Access Compliance Report

Public Rights-of-Way

(Curb Ramps)

Intersection ID: 29394	Main Street: AMBERGLADES_LN	Cross Street: GARDENIA_ST	Location: SW
ADA ID: 776FD848A52D	Ramp Type: PerpDiag	Initial Pass/Fail: Fail	Overall Compliance: No
Severity Score: 8.75			
Codes/Mitigation Info/Possible Solution		Field Measurements/Component Compliance

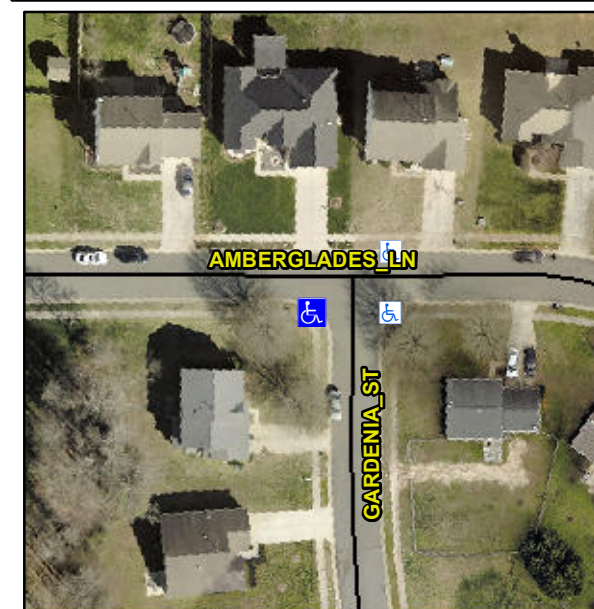
Not Found, R304.5.1

Compliance	Description	Data	Compliance	Description	Data
N/A	Ramp Length (in)	48.5	Yes	Ramp Slope (%)	5.5
No	Ramp Width (in)	46.0	Yes	Ramp XSlope (%)	1.2
N/A	Flare Type LT	N/A	N/A	Flare Type RT	N/A
N/A	Flare Slope LT (%)	N/A	N/A	Flare Slope RT (%)	N/A
N/A	Flare Traversable LT?	N/A	N/A	Flare Traversable RT?	N/A
N/A	Landing Length (in)	N/A	N/A	DWS Provided?	N/A
N/A	Landing Width (in)	N/A	N/A	DWS Contrast?	N/A
N/A	Landing Slope (%)	N/A	N/A	DWS Length (in)	N/A
N/A	Landing X Slope (%)	N/A	N/A	DWS Full Width?	N/A
N/A	Landing Curb? (Y/N)	N/A	N/A	DWS Offset (in)	N/A
N/A	Shared Landing?	N/A			
N/A	Gutter Ponding?	N/A	N/A	Gutter Slope (%)	N/A
N/A	Gutter Lip Ht (in)	0.5	N/A	Gutter X Slope (%)	N/A
N/A	Painted X Walk1?	No	N/A	Painted X Walk2?	No
	X Walk 1 Direction	To E		X Walk 2 Direction	To N
N/A	X Walk 1 Width (in)	N/A	N/A	X Walk 2 Width (in)	N/A
	X Walk 1 Slope (%)	2.8		X Walk 2 Slope (%)	3.5
	X Walk 1 X Slope (%)	3.0		X Walk 2 X Slope (%)	3.6

Remove & Replace Curb Ramp With Two New Directional Ramps or Equivalent.
